NEWFOUNDLAND AND LABRADOR HYDRO

Protection Systems Impacts on 4 January 2014 Supply Disruptions

22 March, 2014 ENVILLE

Figure A1-2 Single Line Diagram of Sunnyside Substation

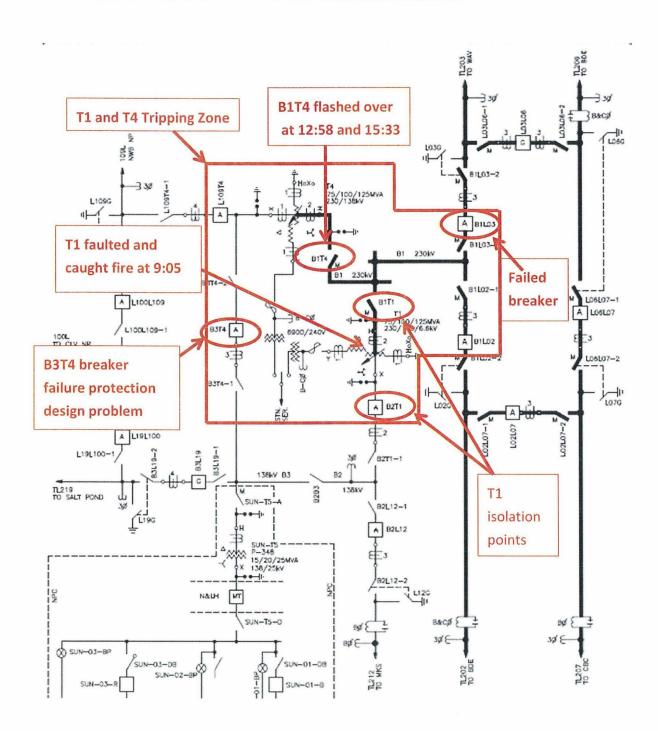
T1 and T4 lockout relays are designed to trip all 5 breakers in the tripping zone shown in Figure A1-2, and maintain that tripping signal to the 230 kV breakers until after the faulted transformer has been isolated by its HV disconnect switch. Tripping of 138 kV breakers on the unfaulted transformer is also blocked if the faulted transformer has been isolated by its HV disconnect switch. However, the lockout relays initiate breaker failure protection **only** for 138 kV breakers in the tripping zone, not 230 kV breakers. The reason for not initiating breaker failure protections for the 230 kV breakers is not known, but is a key causal factor in the spread of the impact of the T1 fault beyond Sunnyside Terminal Station. The reason for initiating breaker failure protection through a different logic than initiating tripping is not clear. Newfoundland and Labrador Hydro do not have written guidelines as to the application or

By design of the tripping scheme, tripping of 230 kV breakers B1L02 and B1L03 is blocked by the B3T4 breaker failure protection through a non conventional application of the breaker failure protection relay retrip function. Non conventional application of the breaker failure protection relay retrip function (during design) was a key causal factor of the opening of disconnect switch B1T4 under load at 15:33 and its subsequent flashover.

Review breaker failure protection applications on all transformer protection designs at stations similar to Sunnyside to check whether all protection systems on both sides of the transformer initiate breaker failure protection systems for all breakers in the tripping zone. Modify where this does not happen. For instance it is clear that breaker failure protection for Sunnyside B1L02 and B1L03 should be modified. This is considered to be a long term recommendation due to the low probability of simultaneous multiple contingencies (i.e., transformer fault together with breaker failure)

Figure A1-3 Voltages and currents at the BDE terminal of TL206 during the 12:58 event. This is the second fault at Sunnyside on 4th January

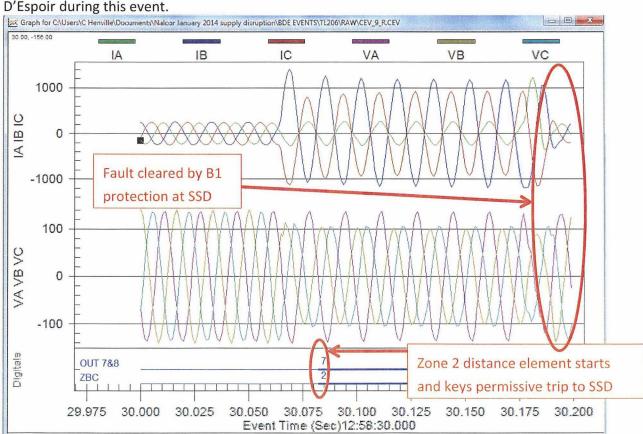
The increase in currents and depression in voltages on phases B and C can be seen. Also, the

start of the phase BC zone 2 distance element can also be seen. These confirm the presence of a phase B to phase C short circuit at SSD B1 at this time.

Figure A1-5 Third (15:33) Sunnyside fault – Digital Fault Recorder Record of Currents, and voltages at Bay D'Espoir Terminal of TL206

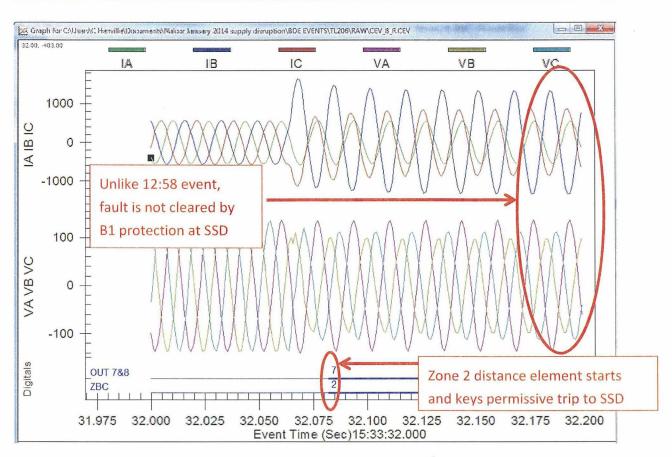
Remote protection at the TL202 and TL206 terminals at Bay D'Espoir attempted to clear the fault by zone 2 delayed tripping after 0.3 seconds, but breakers at the TL202 terminal were slow to open and an additional delay was incurred until the breaker failure protection for both breakers timed out. The breaker failure protection eventually opened the two slow breakers plus additional breakers at Bay D'Espoir to shed additional generation and trip TL204. Tripping of TL202 and TL206 removed all remaining 230 kV supply to the Avalon Peninsula including St. John's load that had already been restored after the 9:05 incident and Come By Chance

TL206 tripped approximately 0.3 seconds after fault initiation (as expected for the zone 2 time delay). TL202 tripped approximately 0.35 seconds after TL206 due to the additional delay resulting from slow tripping, of both of its breakers, and waiting for breaker failure protection.

The following comments are not related to the 4th January disturbance. However, they are important for continued reliable operation of the transmission system. It was found during the 15:33 slow fault clearing event that the TL202 and TL206 zone 2 protection systems operated in 0.3 seconds. An earlier study of these protection systems had revealed that a setting of 0.6 seconds was required to coordinate with the communications independent protection on the Sunnyside terminal of TL207. With a setting of 0.3 seconds there is a risk that if the teleprotection systems fail during or before a fault on TL207 the Bay D'Espoir TL202 and TL206 protections may operate simultaneously with the Sunnyside TL207 and cause a serious disruption of supply to the Avalon Peninsula. This adjustment of zone 2 delays at Bay D'Espoir terminals of TL202 and TL206 were included in a series of recommendations regarding settings changes and other modifications from earlier studies of 230kV protection systems East of Bay D'Espoir. It seems that not all of the recommendations from these earlier studies have been implemented. Some of the recommendations were awaiting protection system replacement projects, or other projects. However it is possible that some recommendations may be best implemented independently of other projects, and in view of their importance, should be implemented without undue delay.

Adjust the time delay on the Bay D'Espoir TL202 and TL206 zone 2 elements from 0.3 seconds to 0.6 seconds. Note that previous implementation of this recommendation would not have affected the 4th January disturbances, but could be important to reduce the probability of future major disturbances. This adjustment has been implemented.

<u>Figure A1-6 Western Avalon T5 fault (12:22) – Digital Fault Recorder Record of Currents, and voltages at Sunnyside</u>

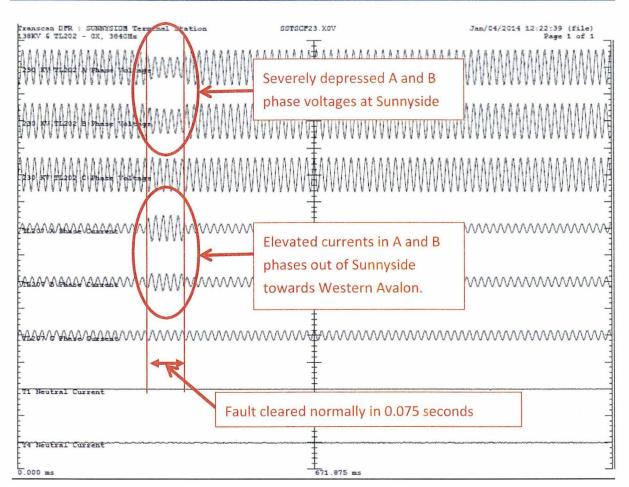
Records retrieved from DFRs at nearby stations (Sunnyside and Holyrood) show that the T5 fault was severe, between phase A and phase B, without ground being involved, and was cleared in less than 5 cycles, which is well within expectations for the protection system. See Figure A1-6 for currents and voltages at Sunnyside during the fault at Western Avalon.
